TORLINE ADDITION

Re: S/D 94-84 - TORLINE ADDITION (Final Plat)

Re: S/D 94-84 TORLINE ADDITION (Final Plat)

CASE NUMBER: S/D 94-84 TORLINE ADDITION

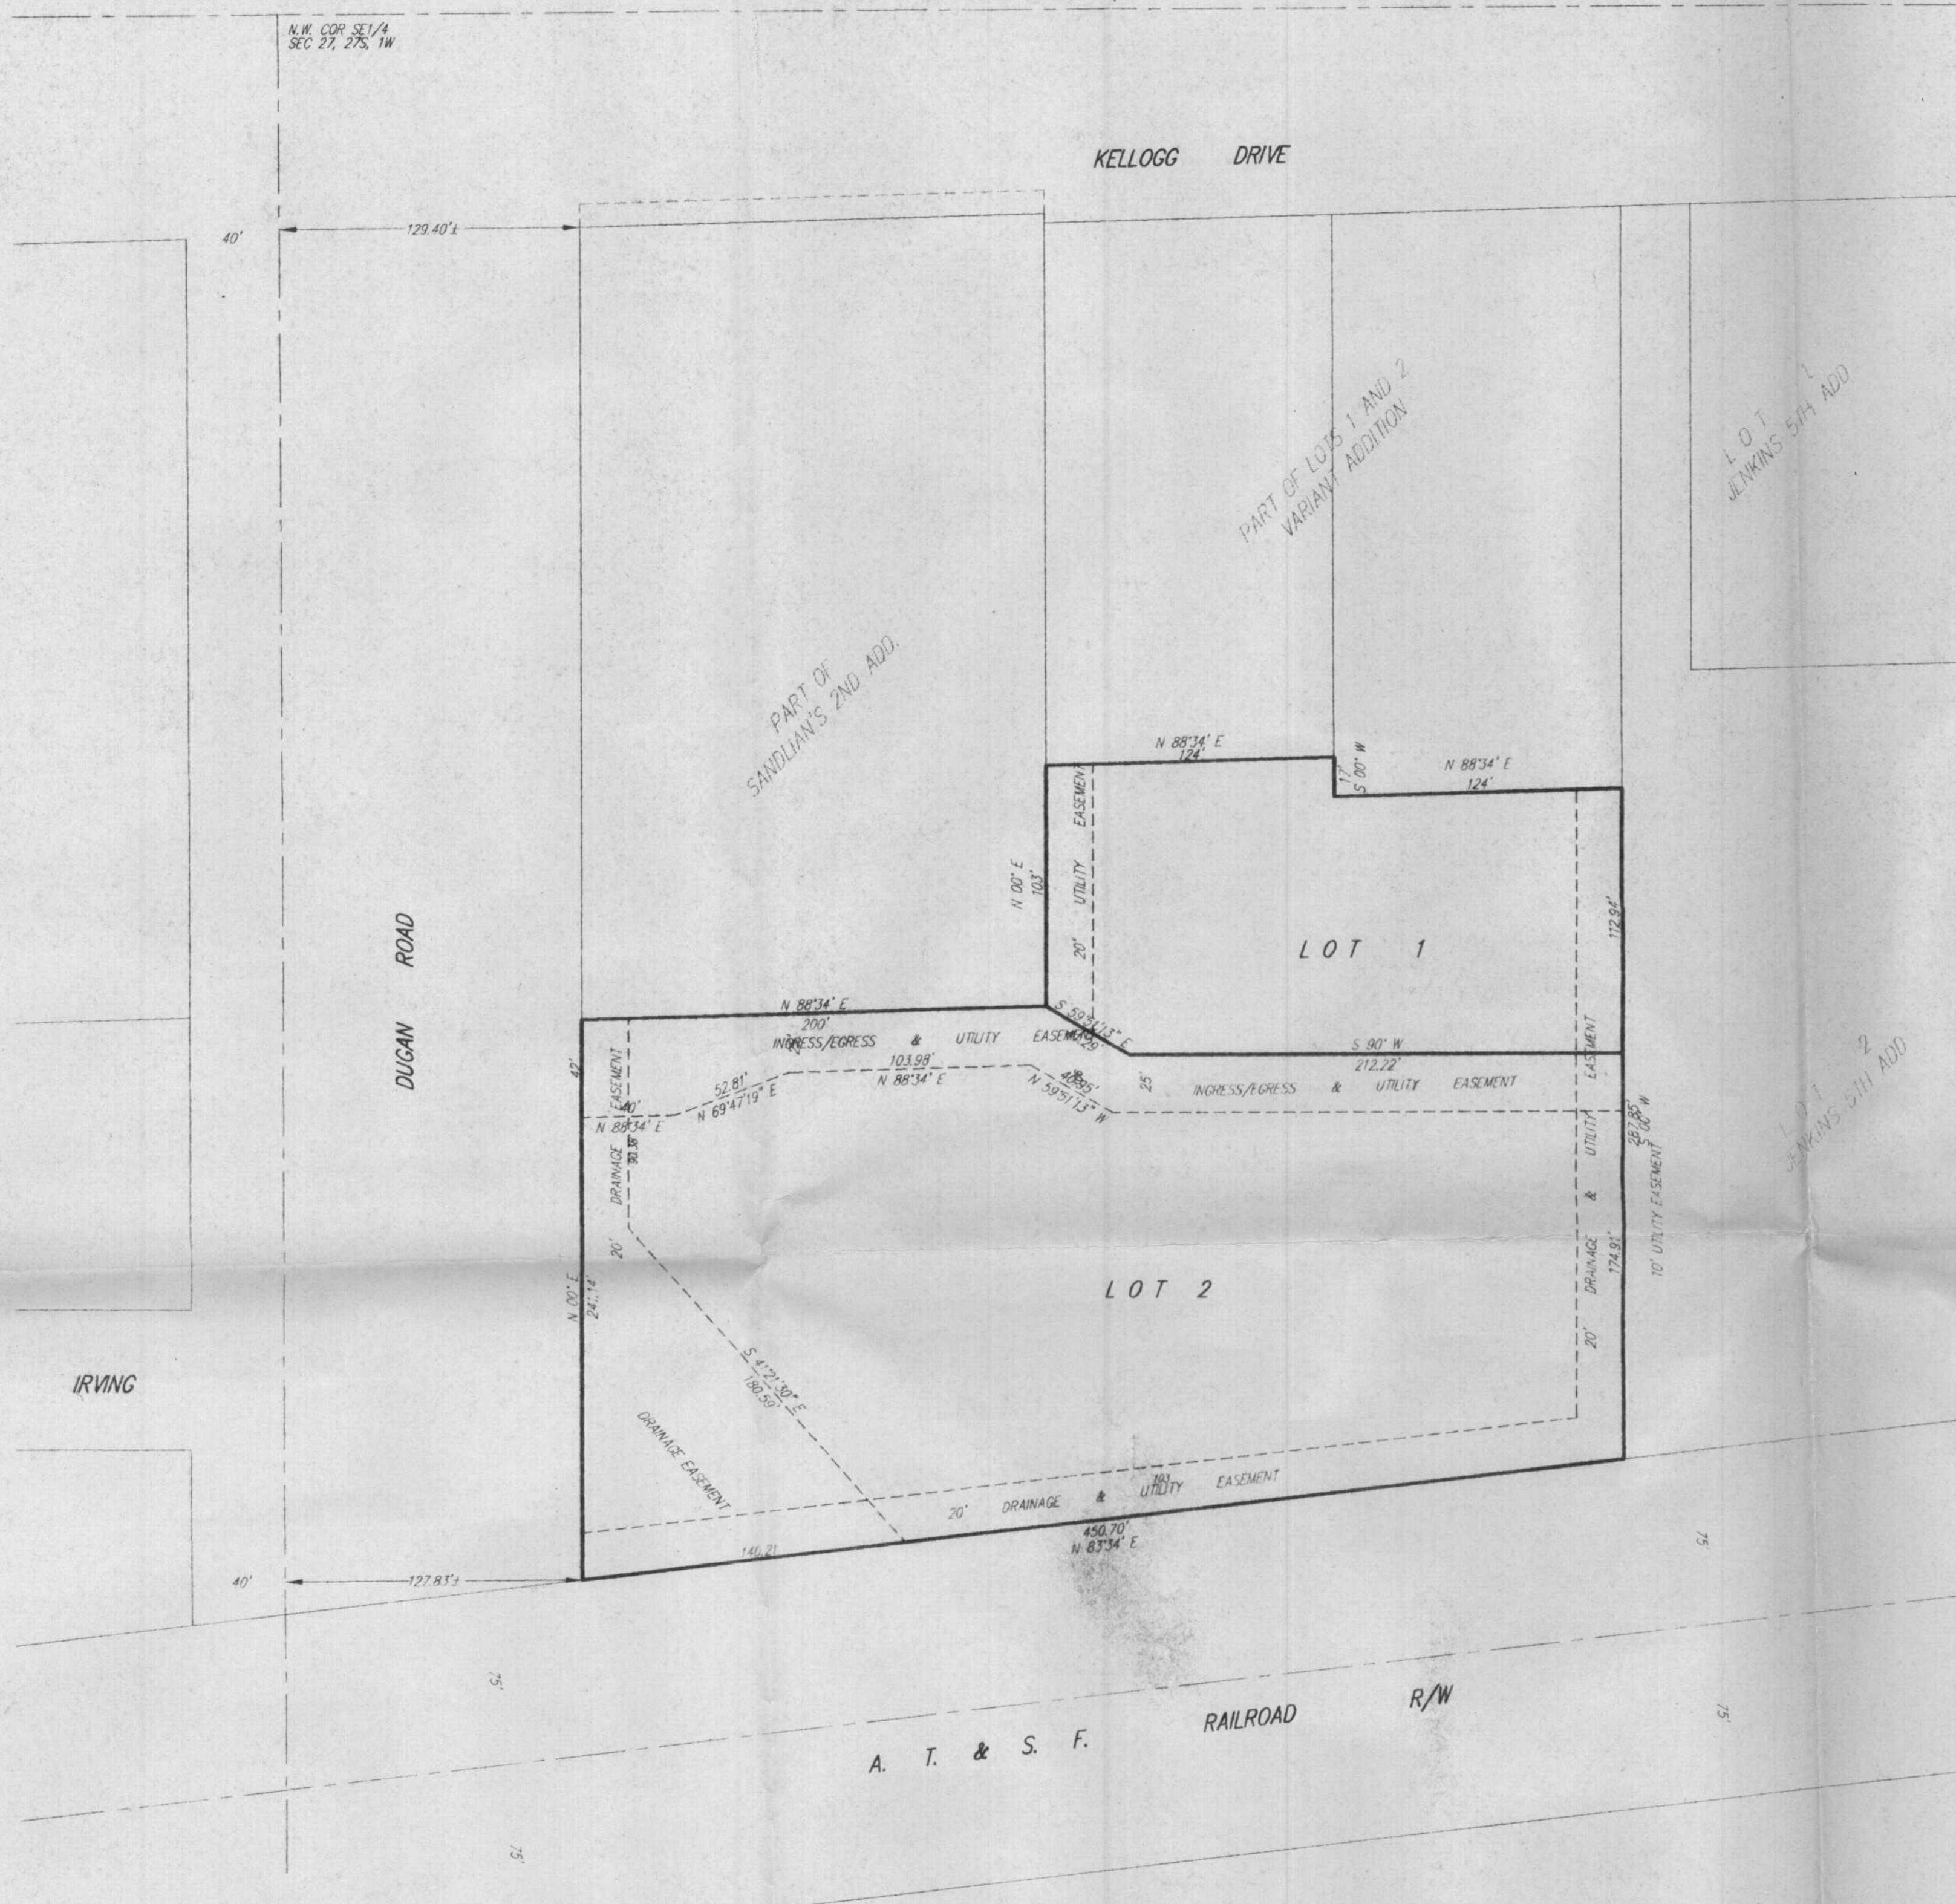
- A. The applicant shall guarantee both the abandonment and reconstruction of sanitary sewer to serve this site. As requested by City Engineering, temporary easements shall be submitted for any existing facilities intended for relocation and not being covered by a platted easement in this addition.

- B. As necessary, the applicant shall guarantee the extension of municipal water to serve the lots being platted. In particular, an extension to Lot 1 may be needed if a private easement cannot be obtained to cover the existing service line to the building now located on this lot.

- C. The applicant shall guarantee any drainage improvements required by the platting of this property. As requested by City Engineering, a temporary drainage easement shall be submitted which covers the existing drainageway until such time as the intended improvements are complete.

- E. Since it is likely that the only access to this site from Dugan will be in the area of the Ingress/Egress easement, complete access control shall be indicated to Dugan along Lot 2's frontage south of this easement. Both the face of the plat and platting text shall note such access control.

- F. While the Subdivision Regulations allow commercial sites to provide access by means of

an access easement rather than direct access to a public street, such easement is a privately established and maintained situation. However, the applicant is required to create and record such an easement. This easement then needs to be shown on the plat tracing with the recording information. The easement also needs to first be submitted to Planning for review. This easement needs to specify who will benefit from the easement, who will install and maintain within the easement the required driving surface, that the easement cannot be impeded in any way, and the easement is binding on future owners or assigns.

At a minimum, the plattor's text shall also note the creation of such a private ingress/egress easement, noting also which property it benefits and that it is not to be blocked in any way.

- G. On the final plat, a 35 foot building setback shall be platted along this site's frontage to Dugan, that is in the area not now encumbered by easements at least 35-feet in depth from Dugan.

- H. If this plat is dedicating any right-of-way for Dugan, it shall be indicated on the face of the plat and the plattor's text shall also note that the street is being dedicated to and for the use of the public. If no such right-of-way is actually being dedicated by this plat, the reference in the plattor's text to such a street needs to be deleted.

- L. On the final plat tracing, the MAPC signature block shall be amended to indicate John W. McKay, Jr., as Chairman.
- M. The applicant shall install or guarantee the installation of all utilities and facilities which are applicable and described in Article 8 of the MAPC Subdivision Regulations (fire hydrants, street signs, monuments, etc.).

- N. The applicant's engineer is advised that the Register of Deeds is requiring the name(s) of the notary public, who acknowledges the signatures on this plat, to be printed beneath the notary's signature.

- R. The final plat shall indicate the utility easements requested by K.G.& E. and Southwestern Bell which are indicated on the enclosed "marked" copy of the plat.
Cons. = 20', but only want 10' now 12/25/94
Also, prior to this plat being scheduled for City Council review, the applicant shall submit letters from KG&E and Southwestern Bell indicating that satisfactory arrangements have been made for the relocation of their facilities made necessary by this plat.

- S. As indicated by City Engineering, the drainage area at the west and southwest portion of this plat should be shown as involving a floodway and the plat's text amended to reference the standard floodway language.
